SPECIFICATION NO. EDTS 254, REV-J

SPECIFICATION FOR 'HARNESS OF UNDERFRAME AND ROOF ARRANGEMENT' FOR LHB EOG FIRST AC COACHES.

This corrigendum is issued to specification no EDTS 254 Rev. 'J' for 'Harness of Under frame and Roof arrangement for LHB EOG 1st AC coaches' to change the scope of supply as follows:

This corrigendum is issued to Specification no. EDTS 254, Rev. 'J', Corr-1,2,3,4,5 for 'Harness of Under frame and Roof arrangement for LHB EOG AC-First AC Coaches' to change the Scope of Supply as follows:

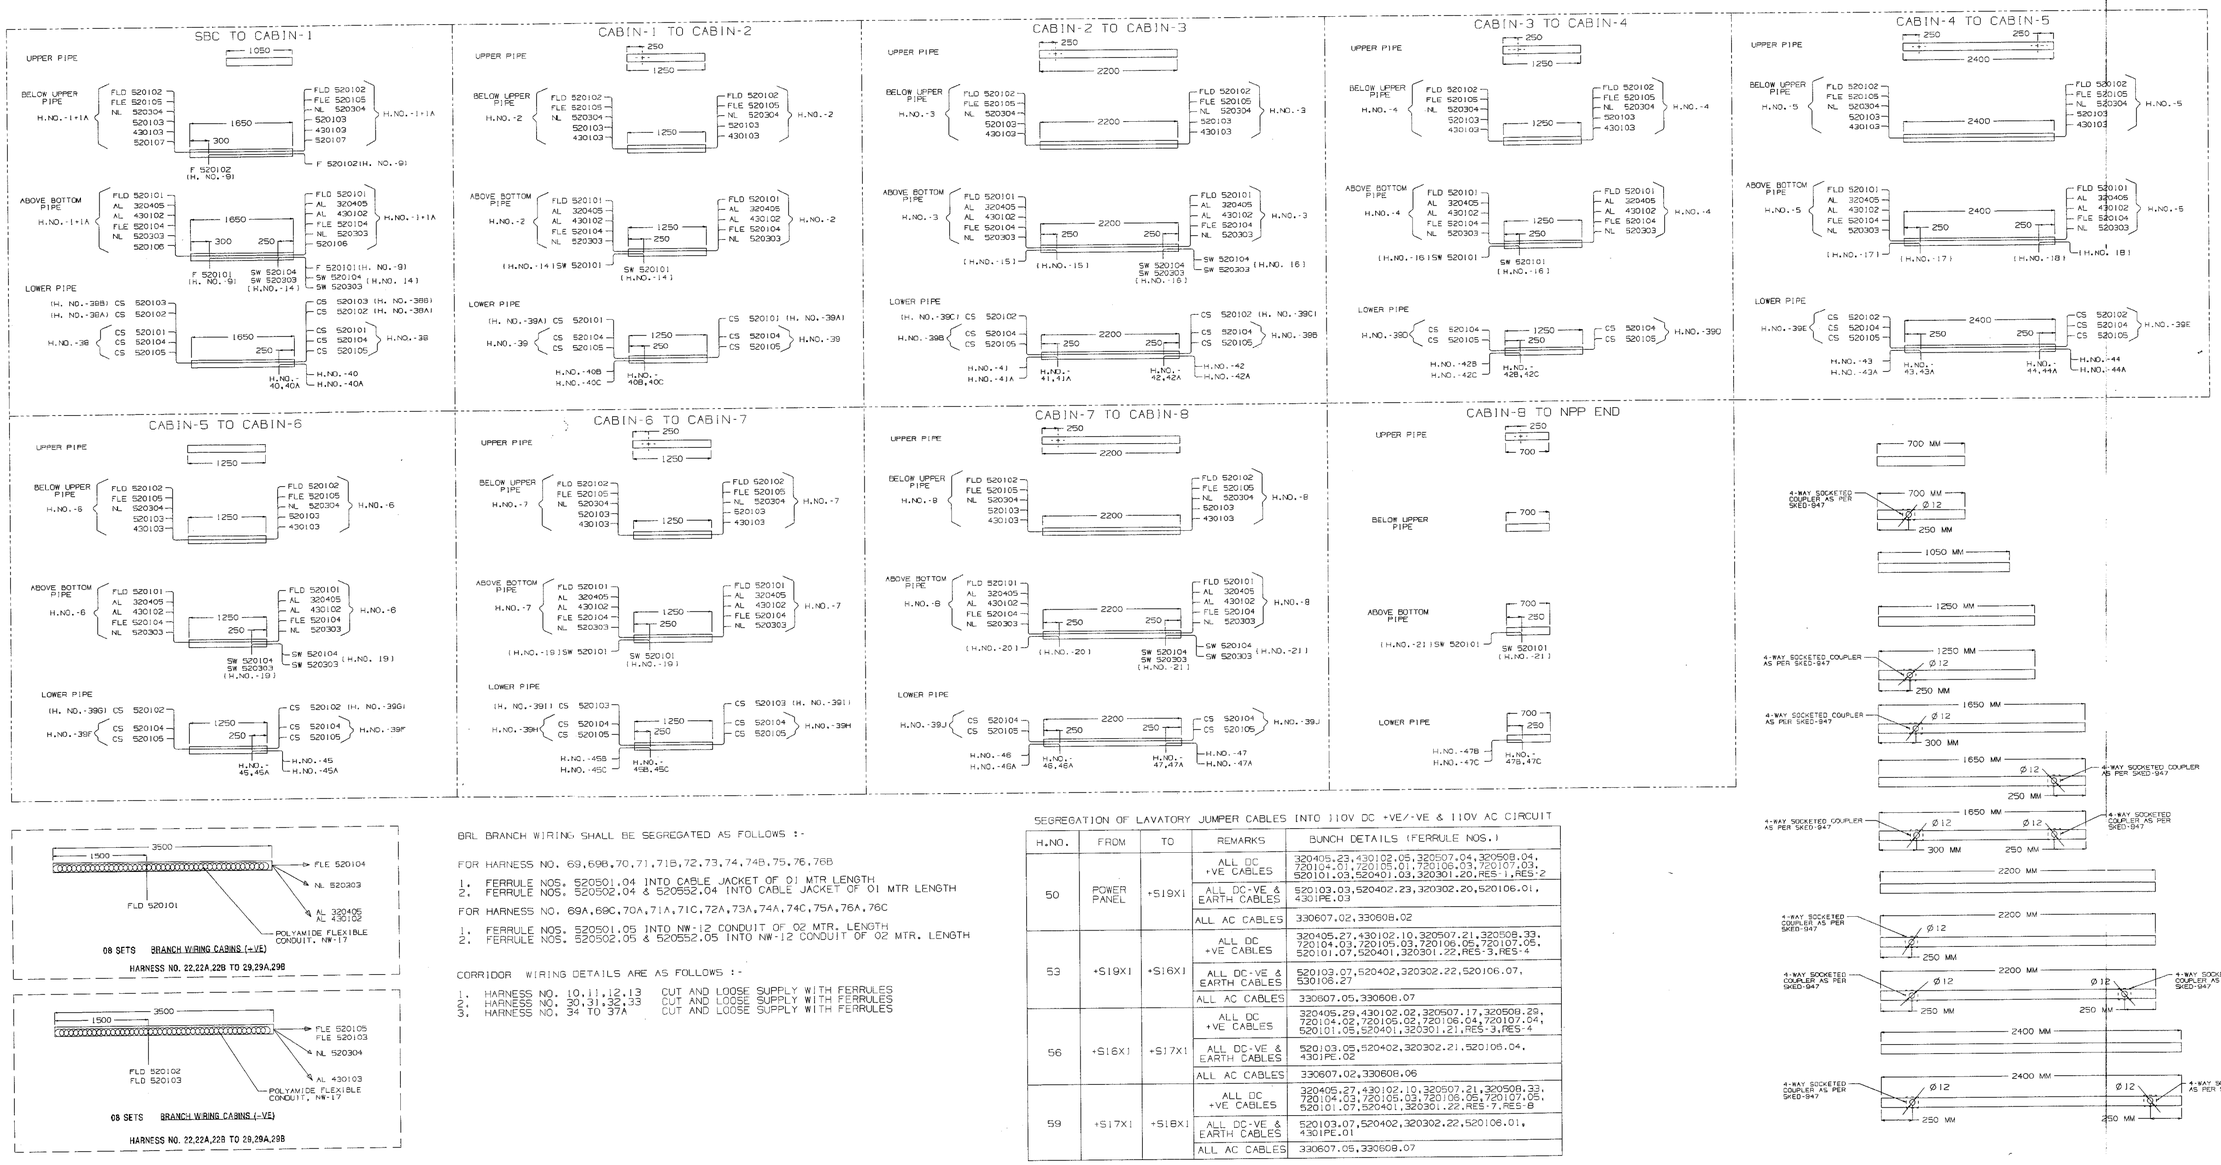
1. *Conduit Arrangement for Jumper & Branch Wiring shall be made as per Drawing No.* **SKED-956.**
2. Wiring for Lavatory, AEL, WC Light, PACIL Circuits etc. on both sides shall also be properly segregated into 02 nos. different Polyamide flexible Conduits and provisioning of Cable Jackets (i.e. 110V DC +VE cables in one conduit and 110V DC –VE/Earth Cables in other).
3. Coach Alteration Instruction (CAI) Sheet to CAI No. ED/CAI/037 for **"Segregation of 110V DC (+VE) and (-VE) at all levels, and provisioning of Cage Clamp terminals with Glass fuses for Enhanced Fire Safety in LHB EOG FAC Coaches"** shall also be referred.

S. No.	Drawing/Spec. No.	Description
9	SKED-956, Alt-Nil	Conduit Arrangement for LHB EOG First AC Coaches (Phase Segregation for 110V DC +VE & -VE)
